Product Change Notification / ASER-22FIFB086

CCB 3104.002, 3104.003 & 3104.004 Final Notice: Qualification of MTAI as a new final test site for selected ATMEGA8xxx, ATMEGA168xxx & ATMEGA88xxx device families available in 32L TQFP (7x7x1.0mm) package

CCB 3104.002, 3104.003 & 3104.004
Pre and Post Change Summary
PCN #: ASER-22FIFB086

Tape and Reel - Carrier Tape

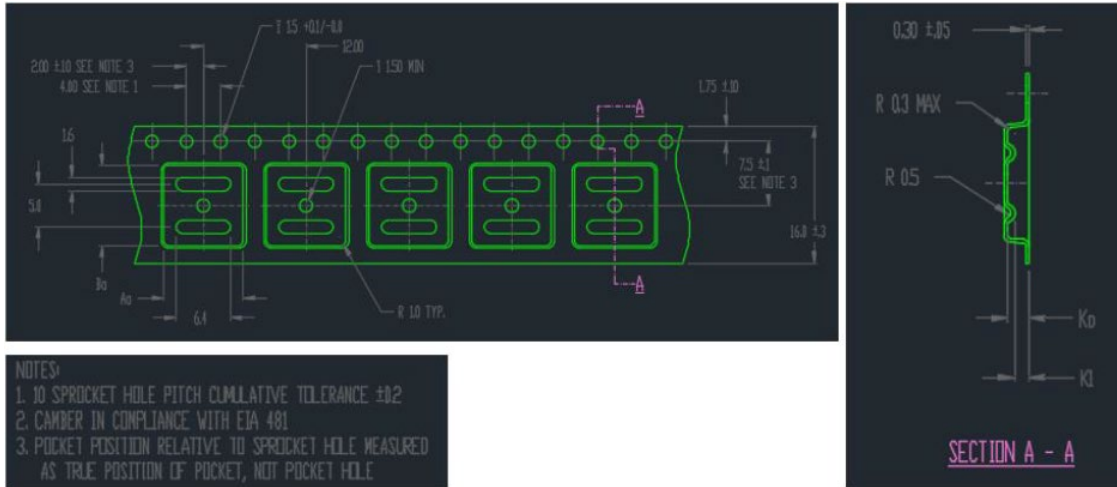
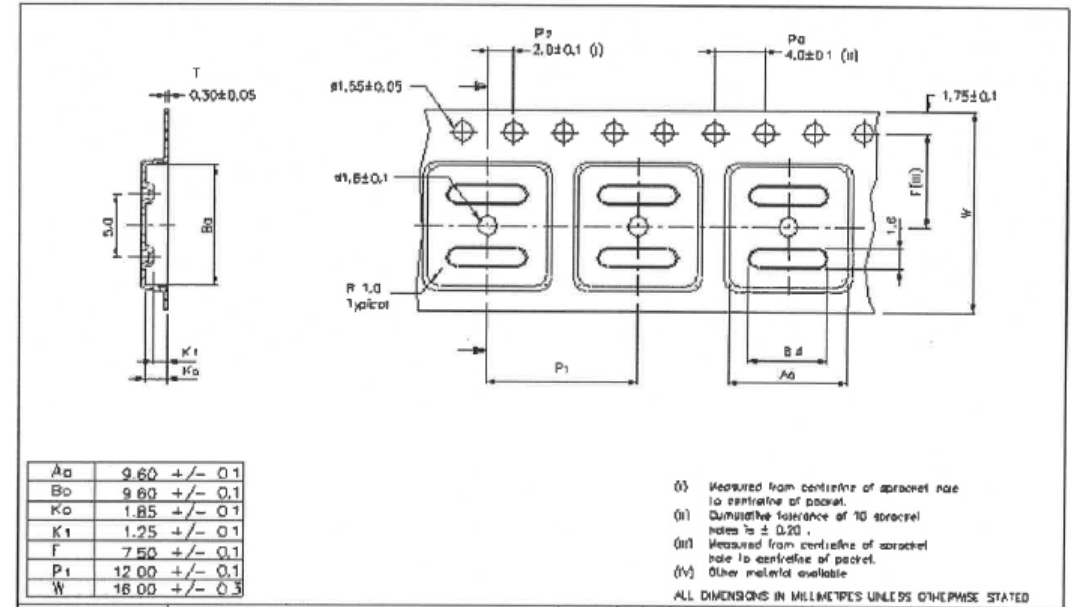
W	P	Ao	Bo	Ko	K1
16.00 (+/- 0.30)	12.00 (+/- 0.10)	9.30 (+/- 0.10)	9.30 (+/- 0.10)	1.80 (+/- 0.10)	1.20 (+/- 0.10)

Thickness	Color
0.30 (+/- 0.05)	Black

W: 16 mm
 P1: 12 mm
 A0: 9.60 mm
 B0: 9.60 mm
 K0: 1.85 mm
 K1: 1.25 mm
 Supplier: C-PAK

Tape and Reel – Plastic Reel

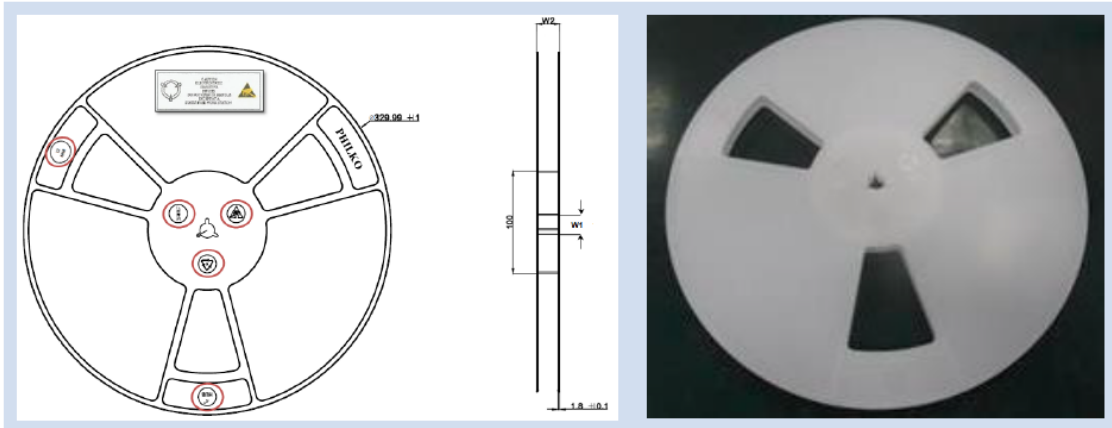
Width	Outer Diameter	Inner Diameter
16	330.2 (+/- 2.0)	100

Color: White

Color: Dark Blue

D: 330

Hub: 4 inch (100mm)

W1: 16.40 mm (+2.00/-0.00)

W2: 22.40 Max
